Value Engineering Study Report
– Final

I-69 Ohio River Crossing Project
Evansville, IN and Henderson, KY

August 2, 2019

Idea Title	Build a four-lane (two lanes in each direction) bridge (I-69) with minimum width shoulders
Function	Support Redundancy

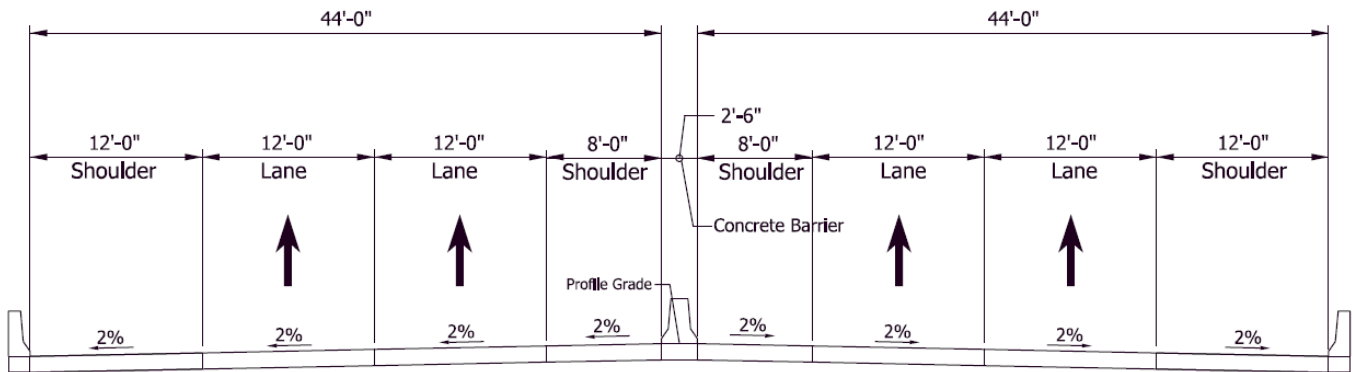
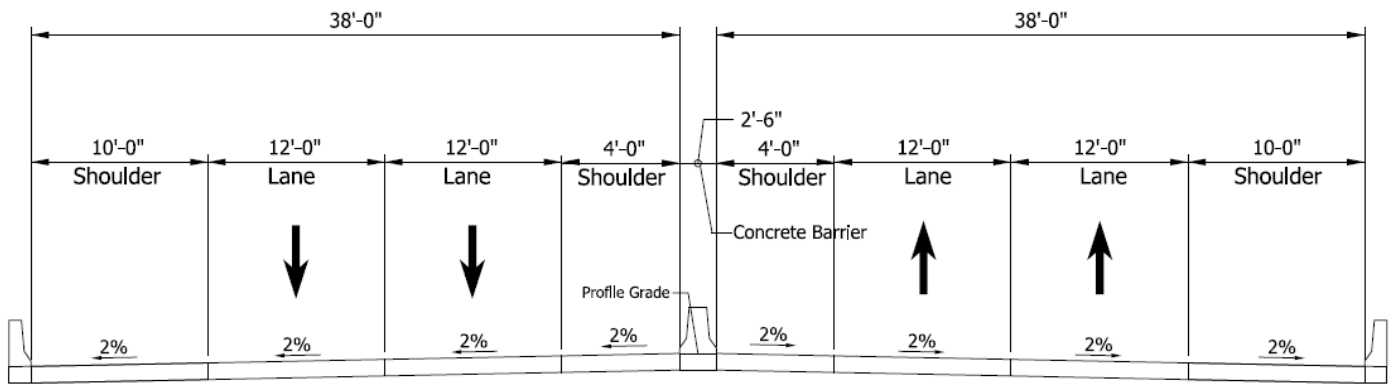
BENEFITS OF ALTERNATIVE CONCEPT:	RISKS/CHALLENGES OF ALTERNATIVE CONCEPT:
<ul style="list-style-type: none"> • Reduces cost of the I-69 Ohio River bridge and approach spans • Still allows for 1+1 / directional closure during future Maintenance of Traffic (MOT) • Still have the ability to have three 11-foot lanes with 2-foot shoulders in the future 	<ul style="list-style-type: none"> • Reduces shoulder widths present challenges for emergency vehicle response • Future widening to 6-lane section would require more construction • Reduces storage for disabled vehicles and police/maintenance operations

During the design of the new I-69 bridge, consideration should be given to potential future expansion of the bridge. The need for expansion could result from either the need to take the remaining US 41 bridge out of service or demand for travel on I-69 that exceeds the capacity of the proposed 4-lane structure.

Idea Title	Remove US 60 interchange
Function	Support Redundancy

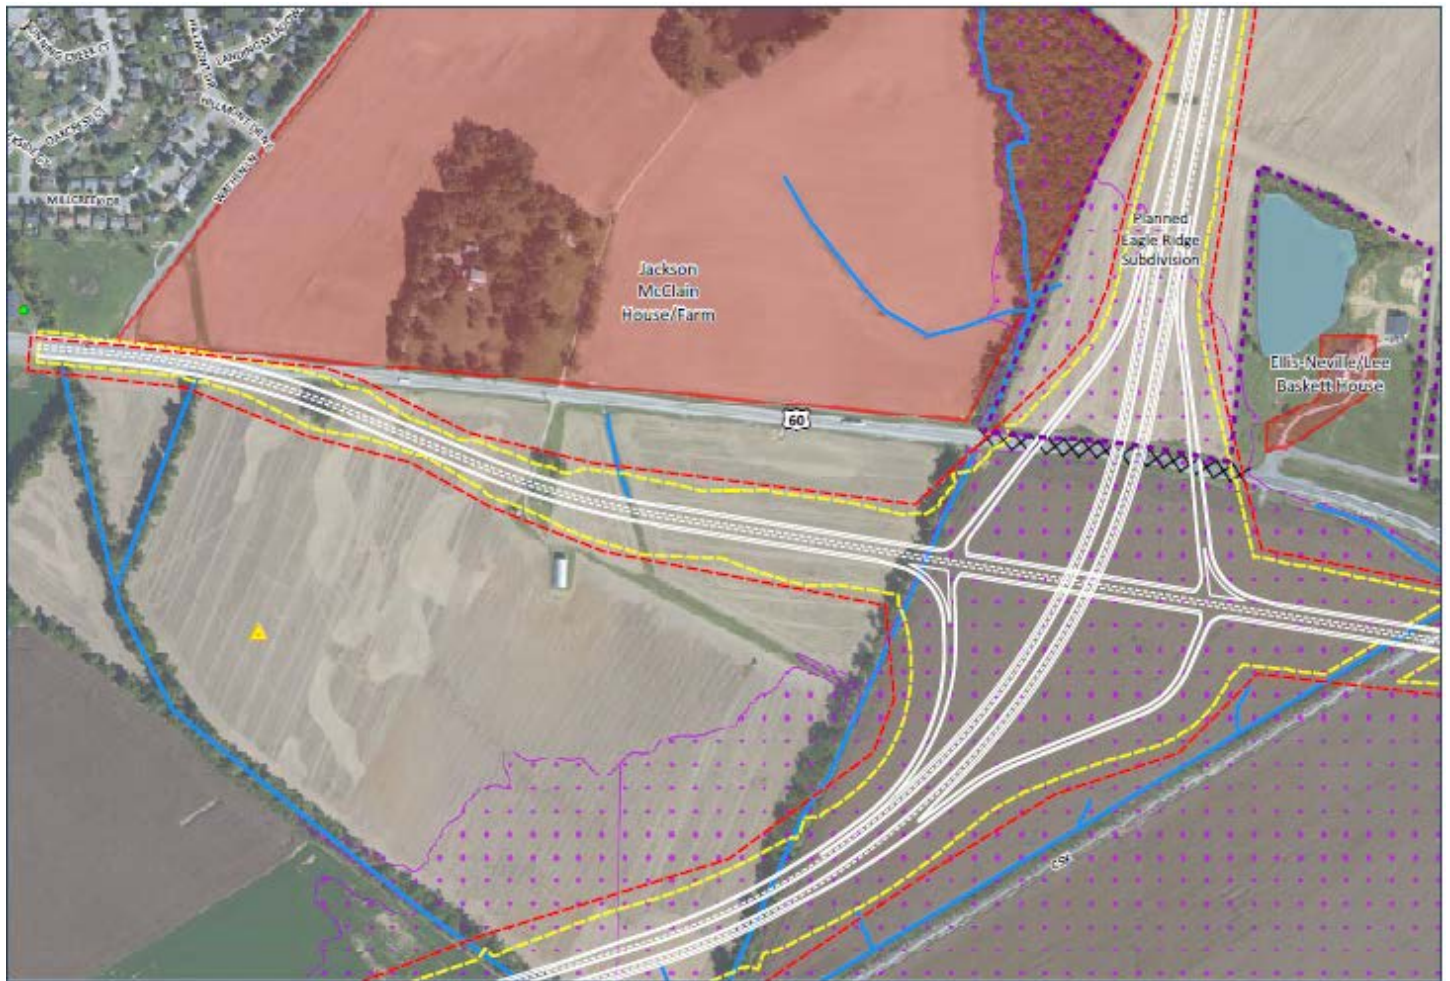
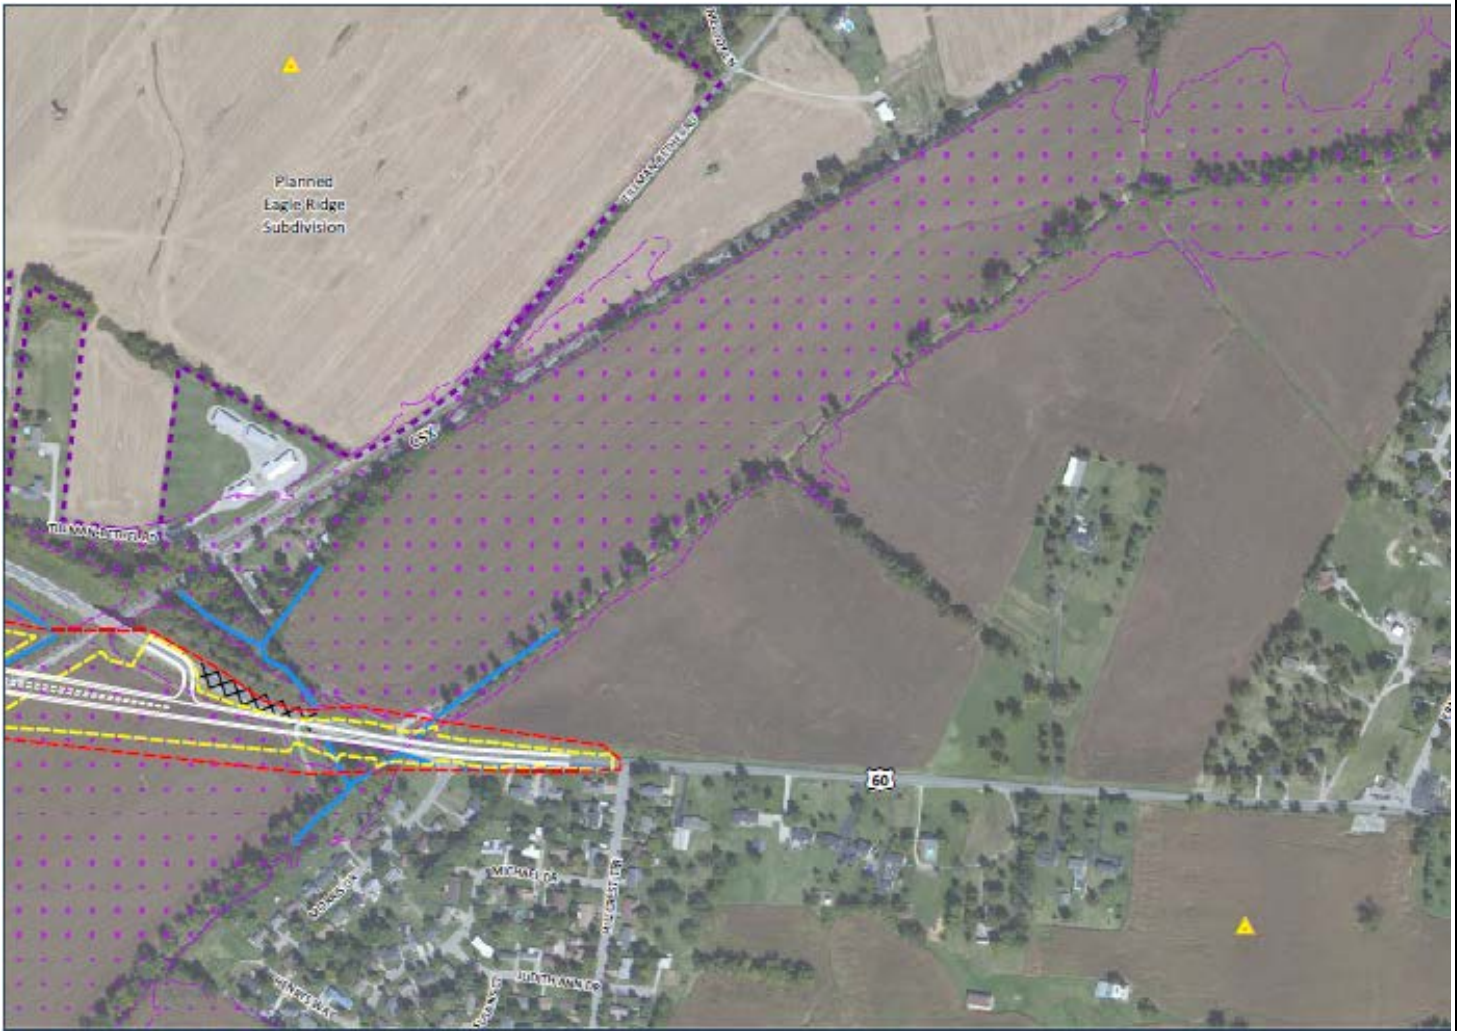
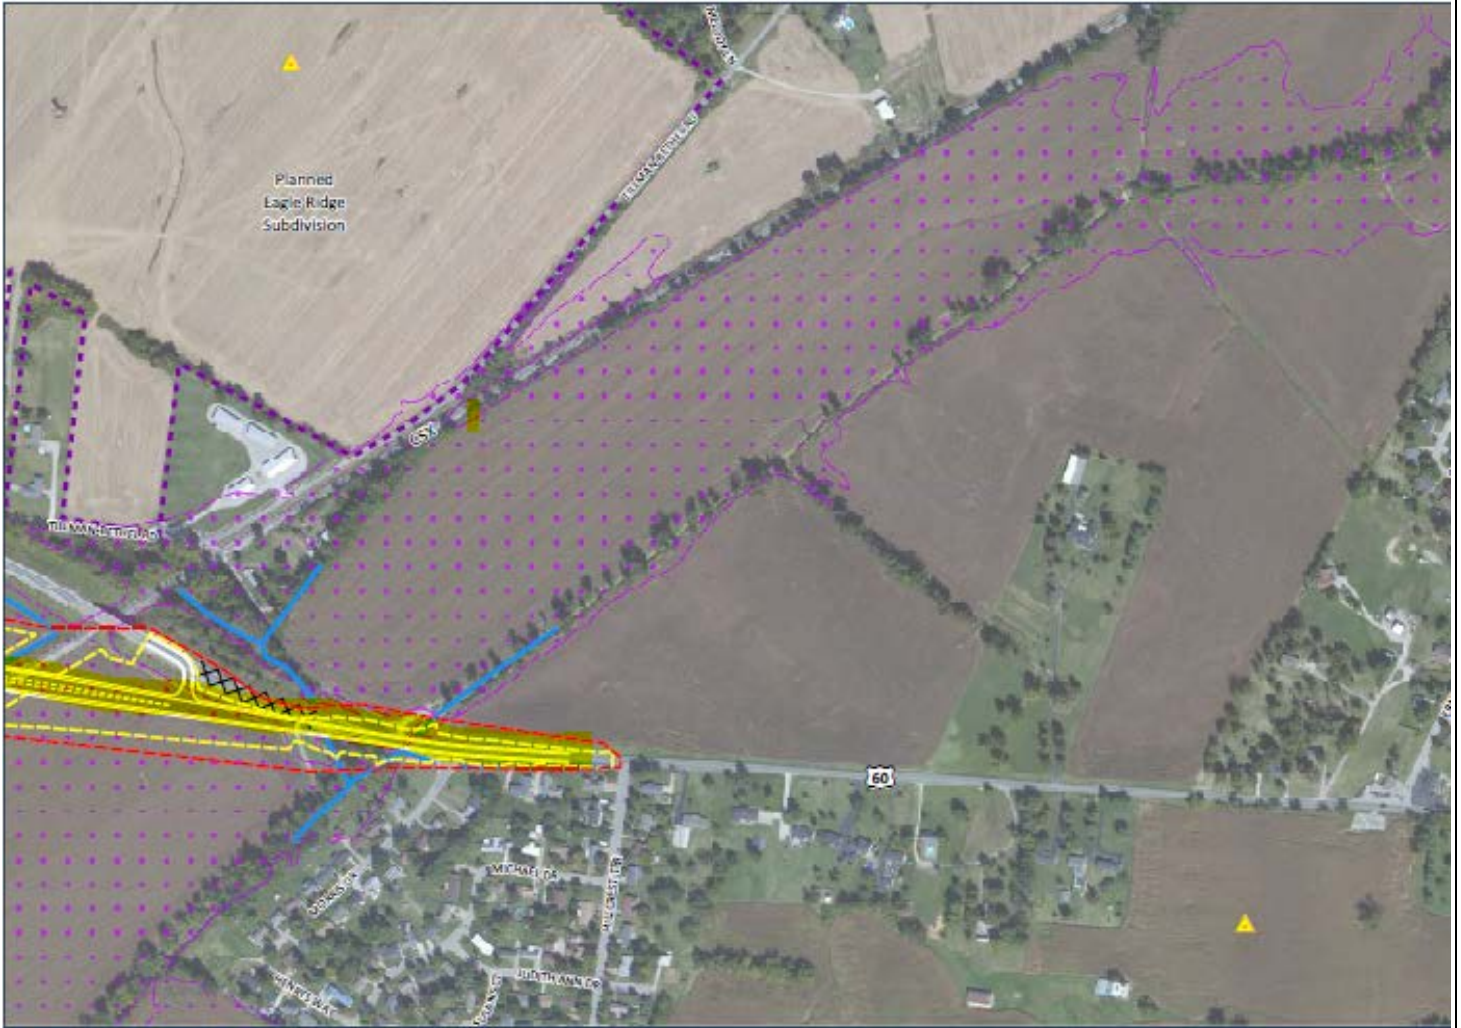
Delete construction of proposed interchange on US 60 at proposed I-69. Leave current US 60 alignment unchanged. Construct I-69 overpass at US 60. Construction of interchange may be built in the future when needed.

Eliminate construction of interchange with US 60 in Kentucky. Build I-69 overpass of US 60. Leave US 60 current alignment unchanged. Allow design of overpass for future interchange construction. This alternate reduces impact to historical properties, reduces right-of-way requirements, reduces cost, and eliminates inconvenience to traffic on US 60. This interchange does not add to the true purpose of the project and clearly eliminating it would save significant money. Impact to growth is minimal, as no development currently exists in the area and future projections show a population decline for Henderson.

This alternate design reduces impact to historical properties and therefore reducing the need for any special waivers, design exceptions, etc.

Idea Title	Remove US 41 Interchange
Function	Support Redundancy

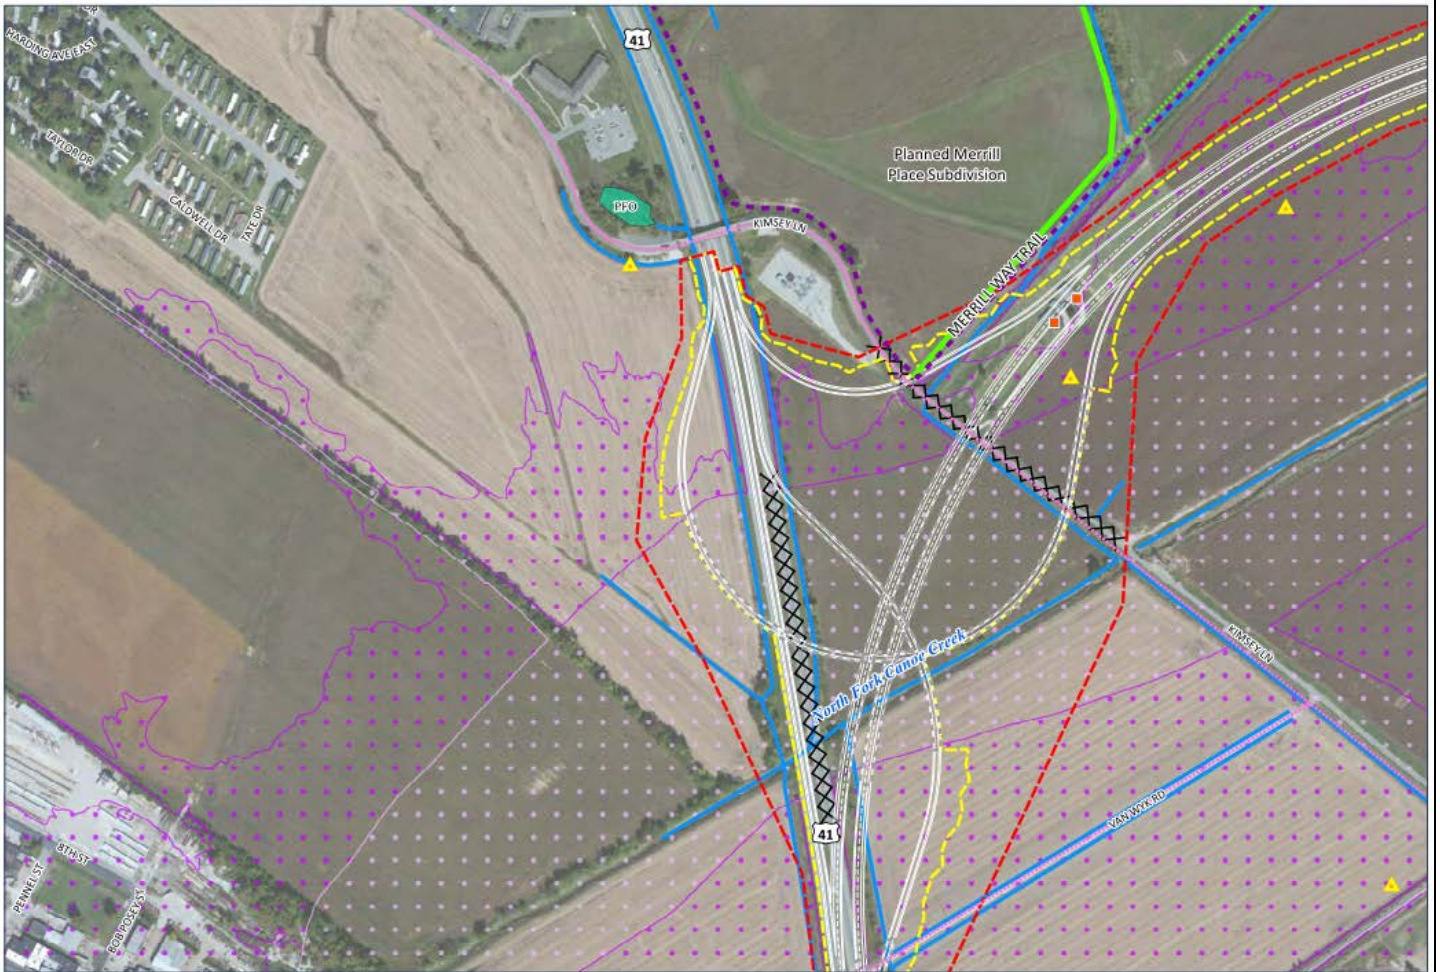
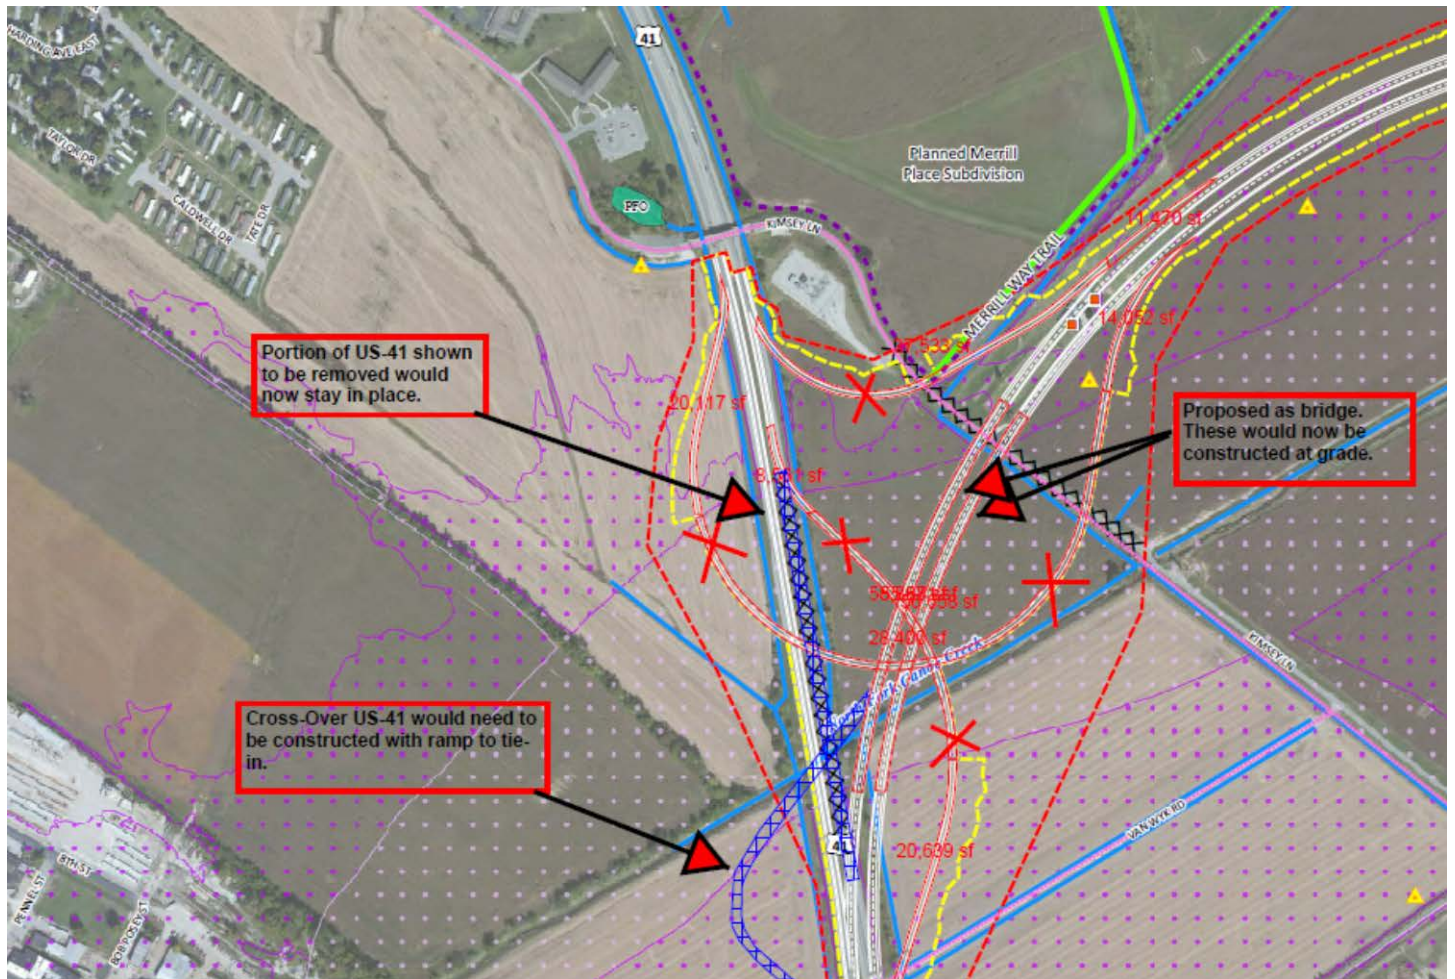
COST IMPACT:	<p><u>Rough order of magnitude impact to cost (potential cost avoidance) - \$45M</u></p> <p>Scope Reductions:</p> <ul style="list-style-type: none"> 200,000 sf of Bridge at \$250/sf = \$50,000,000 12,500 sy of ramps at \$70/sy = \$875,000 Total Reduction = \$50,875,000 <p>Scope Additions:</p> <ul style="list-style-type: none"> 12,500 sy of ramps at \$70/sy = \$875,000 20,000 sf of bridge at \$250/sf = \$5,000,000 Total Add = \$5,875,000 <p>Net Reduction</p> <ul style="list-style-type: none"> \$45,000,000
---------------------	---

Connecting northbound I-69 to northbound US 41 may make it more acceptable to the public.
